SAFETY EVALUATION BY THE OFFICE OF NUCLEAR REACTOR REGULATION

RELATED TO EXTENSION OF THE SCHEDULE FOR

REINSPECTING CORE SHROUD VERTICAL WELDS

NINE MILE POINT NUCLEAR STATION, UNIT 1

Figure 1

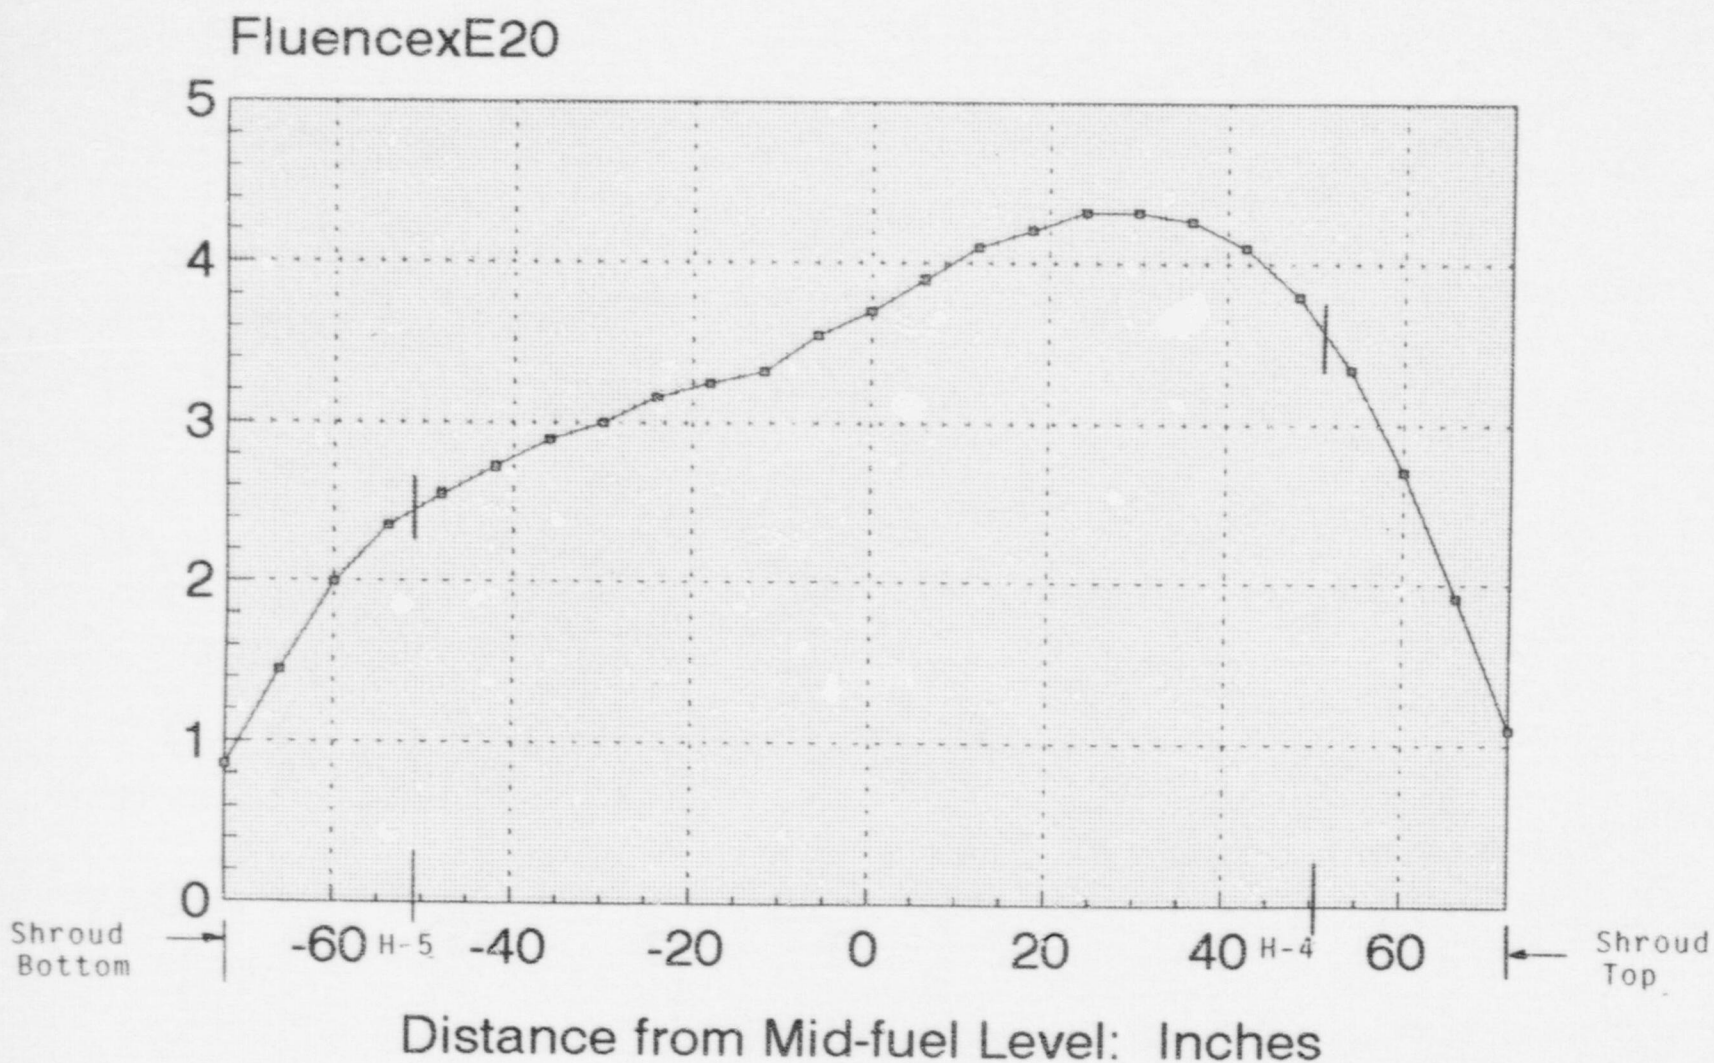
The calculated V-9 and V-10 weld fluence values 14,500 hours after the end of NMP1 operating cycle 12 (i.e., at the projected end of cycle 13), are shown in Figure 1 of this appendix. This can be directly compared to the crack depth profile of both welds as measured at the end of cycle 12, shown in Figure 2 of this appendix. The NRC staff notes that the maximum fluence value occurs at the 27.00 inch elevation above the fuel midplane and is  $4.32 \times 10^{20}$  n/cm<sup>2</sup> (E > 1.0 MeV, see Table A-12 of Report MPM-108679, "Final Report, Nine Mile Point Unit 1 Shroud Neutron Transport and Uncertainty Analysis," forwarded by NMPC cover letter dated October 22, 1998). The V-9 and V-10 welds are azimuthally symmetric with respect to the peak shroud fluence location which is  $4.39 \times 10^{20}$  n/cm<sup>2</sup> (E > 1.0 MeV, see Table A-16 of the same report, at 19.34 degrees on the azimuth). The NRC staff also notes that the maximum crack depth in the V-9 weld coincides with the maximum fluence location, but this is not the case for the V-10 weld.

On the basis of its review of NMPC's submittals regarding the NMP1 shroud fluence evaluation, the NRC staff finds that: (1) the proposed calculated fluence values substantiate the shroud measured values, because they are within the estimated uncertainty limits, (2) the proposed fluence values for the critical shroud welds, V-9 and V-10, are acceptable because they were determined using an acceptable calculational method, and (3) the estimated uncertainty of the calculation is within the NRC staff's recommended uncertainty limits of 20%. Therefore, the NRC staff concludes that the proposed shroud fluence values are acceptable.
